Wolfspeed® Major Product/Process Change Notification

PCN Number:	PCN-00265	PCN Issue Date:	October 28, 2026
PCN Type:	Major

Partial Lot Combination for Wolfspeed Discrete Automotive Devices

Figure 1. *Example Combination of three different date codes that may be combined into a single reel, inner tube, or inner box*

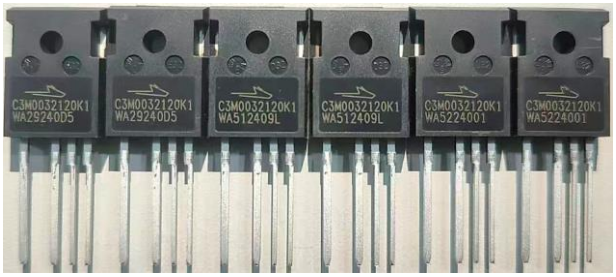
Wolfspeed will implement partial lot combinations on shipping labels for all discrete Automotive devices. This change allows the combination of up to three different date codes into a single reel, tube, or inner box.

- The maximum allowable time variance between date codes will not exceed six months.
- 200mm and 150mm lots will remain separated.
- The label will display all date codes included.
- Each unit will retain its individual lot and box ID, ensuring full traceability.
- For returning parts, please ensure that the relevant label information and delivery note (DN) number are available.

***Figure 2b**. Example of a partial lot combination inner box label with three date codes.*

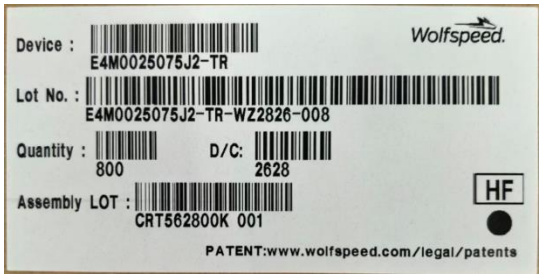
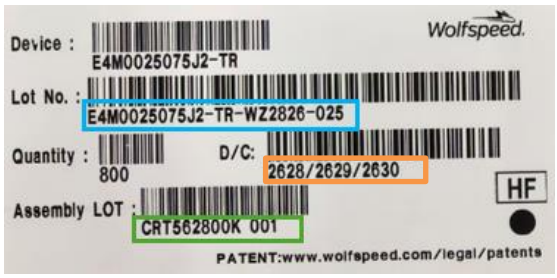
In Figure 2b:

- The **Lot Number (E4M0025075J2-TR-WZ2826-025)** includes the oldest date code (WZ2628) and a unique sequential identifier (-025).
- Each **Partial Lot Date Code** is listed on the label.
- The **Assembly Lot Number (CRT562800K 001)** is a unique number used to track whether parts were included in a partial combined lot.
